RE: Giroux Oil Canopy Addition
343 Warren Avenue
Minor Site Plan
Application ID # 09-79900025
CBL: 303-D-010-001

Amended Site Plan Application
Giroux Oil Company
343 Warren Avenue, Portland, Maine

Jean Fraser - Giroux Oil Company 343 Warren Avenue-Response to preliminary staff comments

SHEET TITLE
 FLOOR PLAN
 & ELEVATIONS

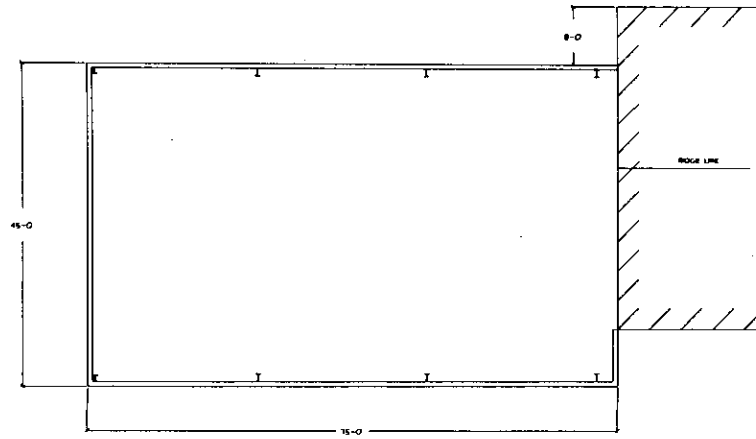
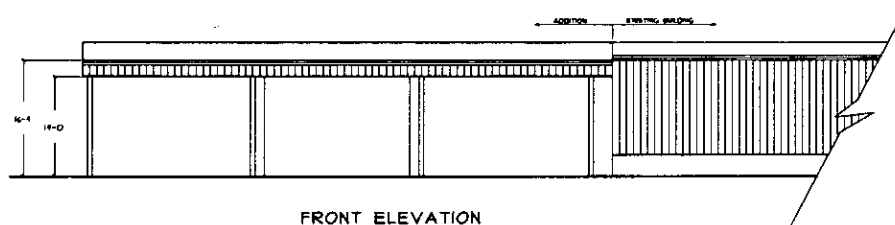
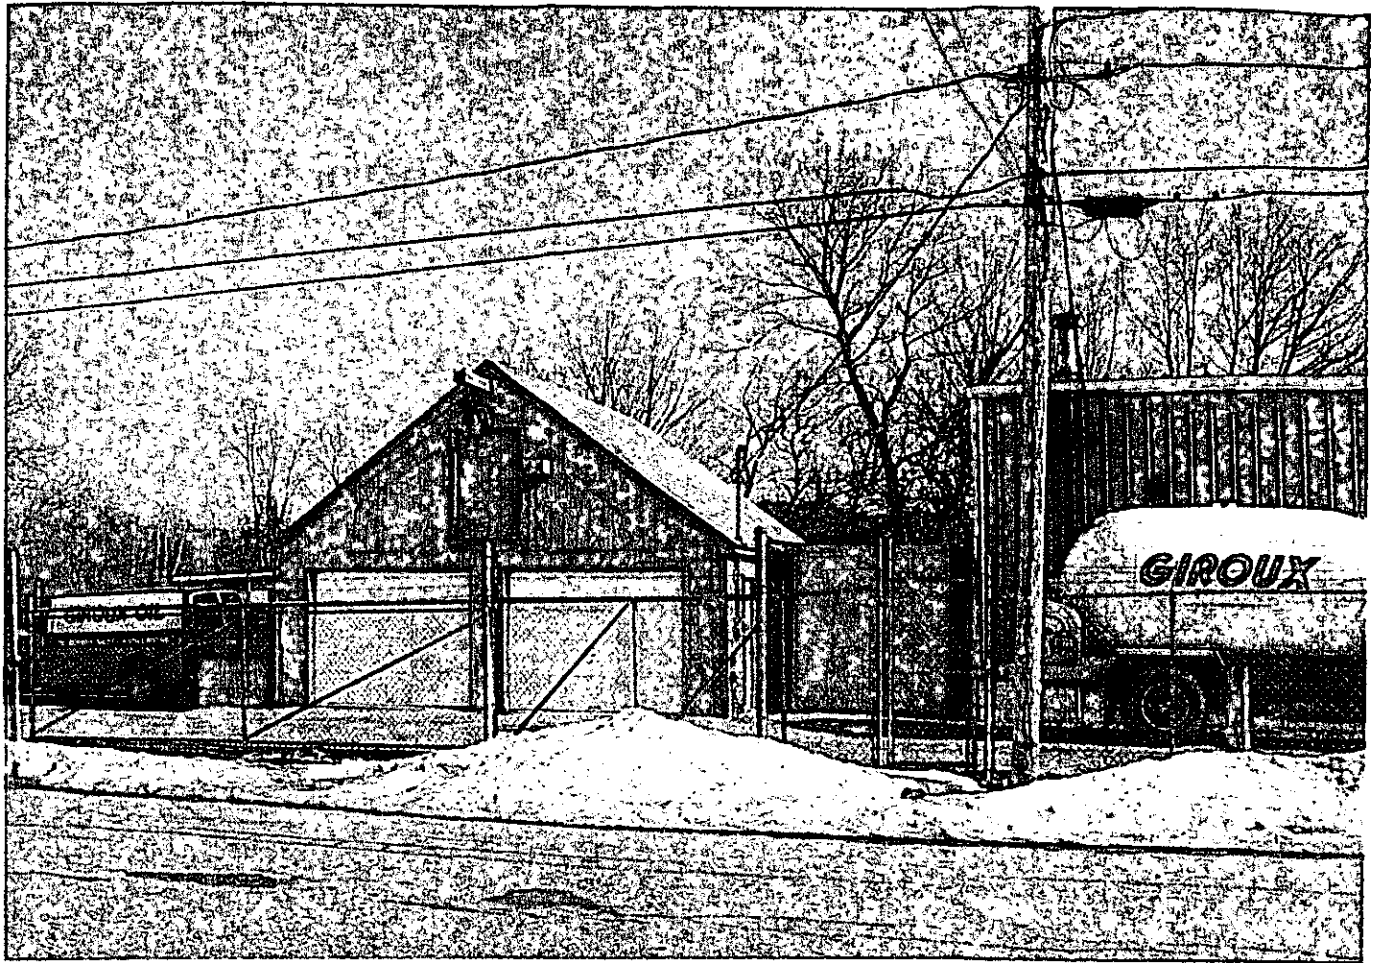
- *What is happening to the small storage building located in the area of the canopy addition?* This building will be removed from the site entirely. The equipment (boilers, new empty tanks, etc.) currently stored in this building will be relocated to under the canopy. This will allow ease of access to these items.
- *Submit a plan showing existing and proposed parking, including information on parking needs.* Our office is currently preparing this plan and information. According to the owners, they have 6 employees in the office throughout the day. They have 5 oil and propane truck drivers and 4 technicians, who are on the road throughout the day. They have a total of 14 trucks, 7 of which go home with their employees each night.
- *Address landscaping:* We are currently assessing the site landscaping provisions
